City of Sunnyvale

PROJECT: 800 Carlise Way Well and Water Tank Project (2022-0741) Response to Late Comments on EIR

DATE: March 9, 2026

Proposed Site Plan

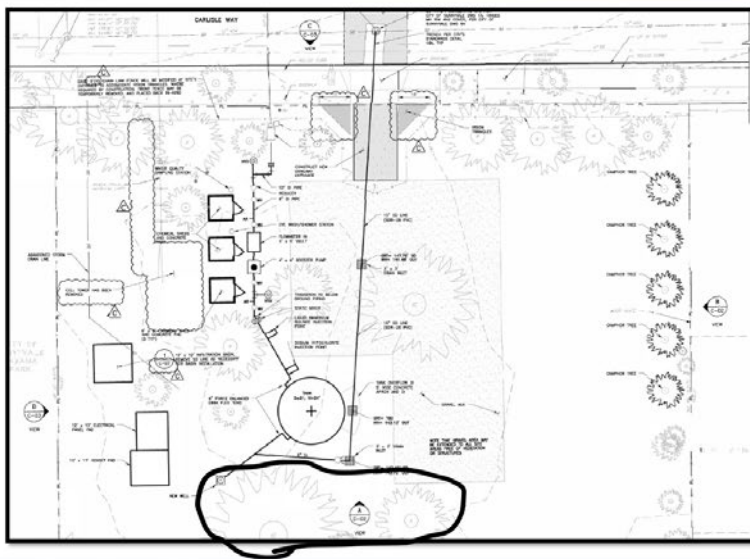
Presentation to Planning Commission 5/27/25, comment says 8 trees to be removed (up from the prior 4) **but no**

This tree is also a nesting site for Coopers Hawks
